PCI-SIG ENGINEERING CHANGE REQUEST

TITLE:	Downstream Port Containment related Enhancements
DATE:	Draft version – September 10, 2018
AFFECTED DOCUMENT:	PCI Firmware Specification, Rev. 3.2
SPONSOR:	Mahesh Natu, Rob Gough (Intel Corporation)

DPC event handling when firmware maintains control of AER and DPC

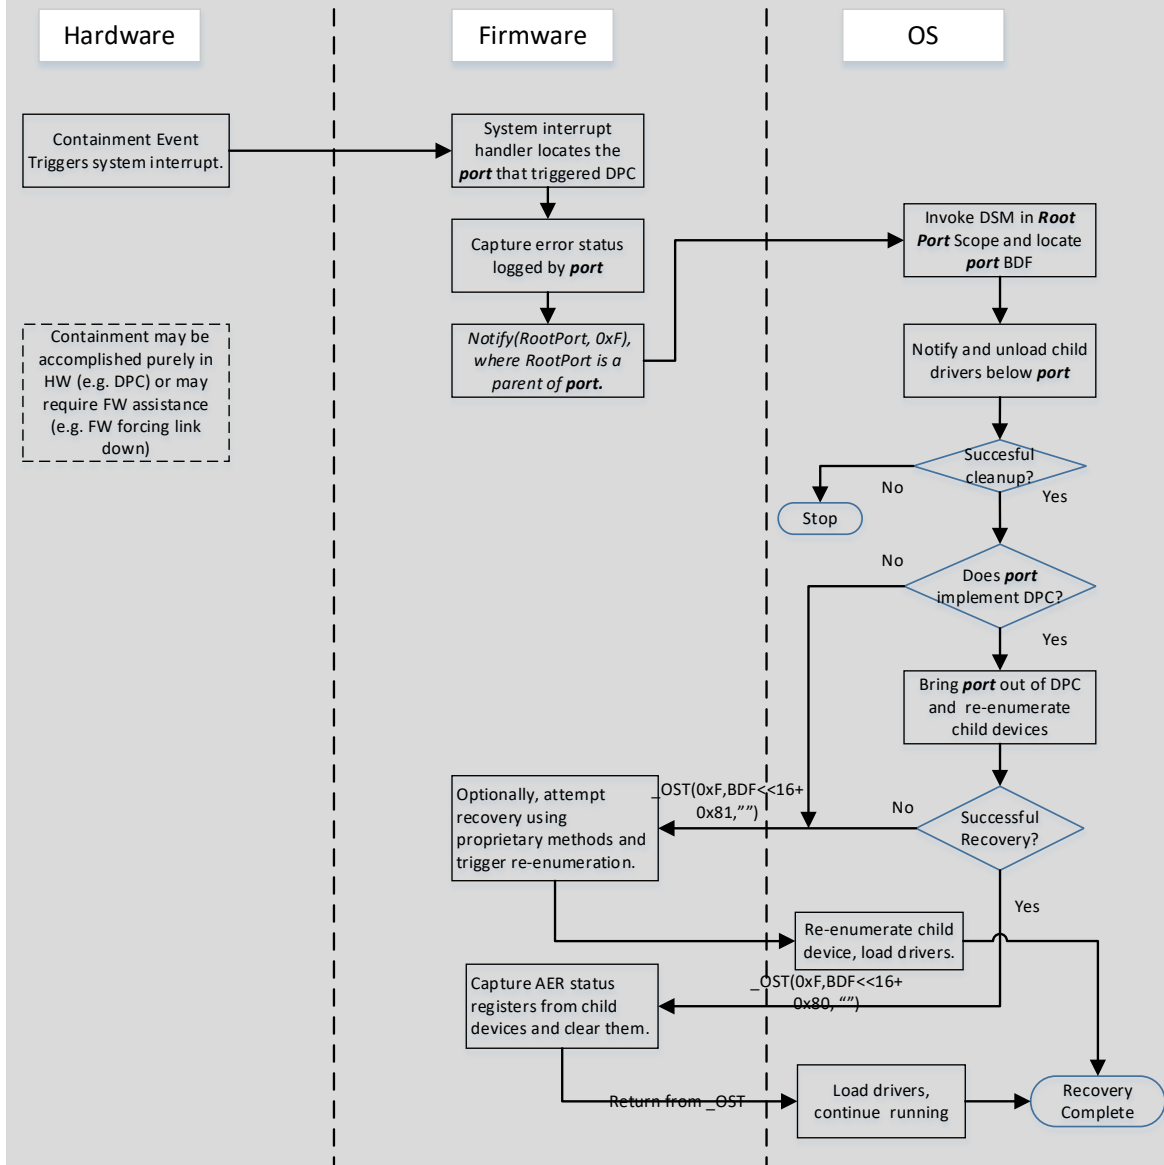
IMPLEMENTATION NOTE
